## SUBDIVISION-LAND DEVELOPMENT WAIVER REQUEST FORM

SUBJECT: Plan Processing Modification Request  
Greiner Industries  
DCG Project Number 3677-54

Re: Stormwater Management Plan for Greiner Industries  
Our File No. 10221-1

Re: Greiner Industries  
Stormwater Management Plan  
Township Permit No. 26-01-WAIV  
LCEC Project No: 25-206

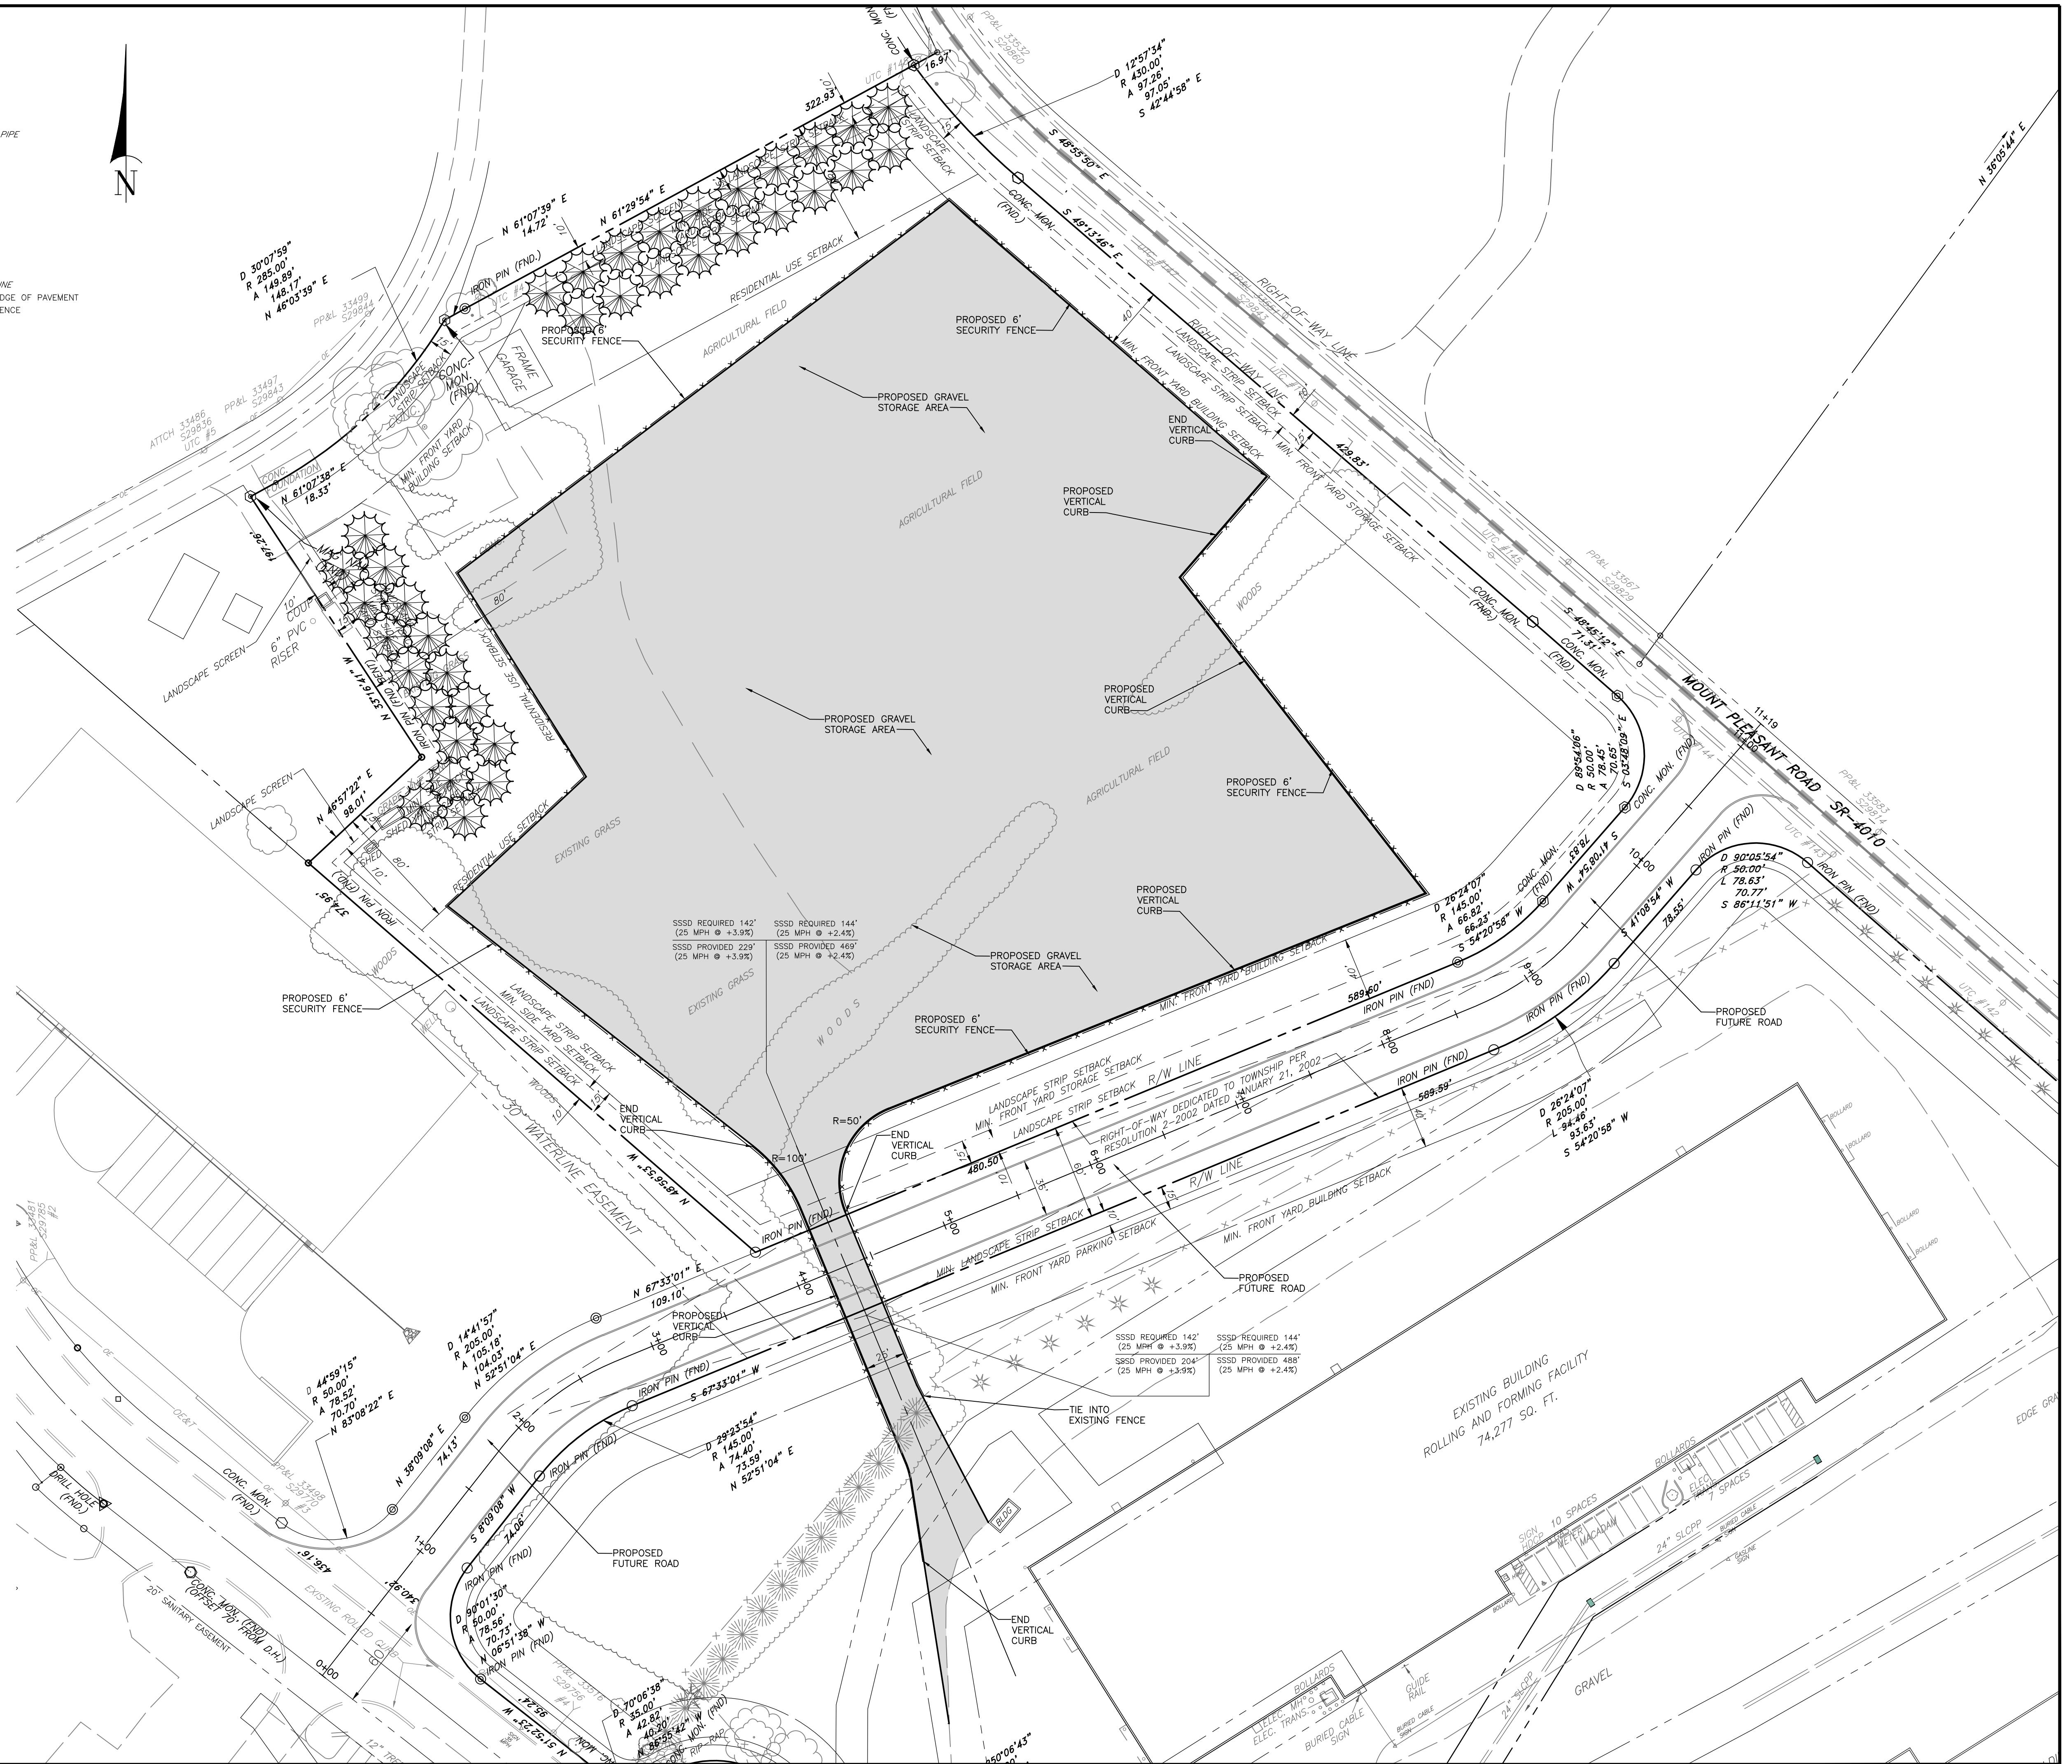
The 2025 Plan shows the proposed street extending from Steel Way Drive eastward to Mount Pleasant Road (the “Proposed Street”). The 2025 Plan states that the Proposed Street was dedicated to the Township per Resolution 2-2002 dated January 21, 2002. I believe this is incorrect. The Proposed Street was established on the Final Subdivision Land Development Plan for Greiner Industries, Inc. recorded at Subdivision Plan Book J-234, Page 14 (the “2008 Plan”). Mr. Greiner conveyed the right-of-way for the Proposed Street to the Township by a deed dated April 18, 2008, recorded at Document No. 5701997. This deed should be the source of the Proposed Street on the 2025 Plan.
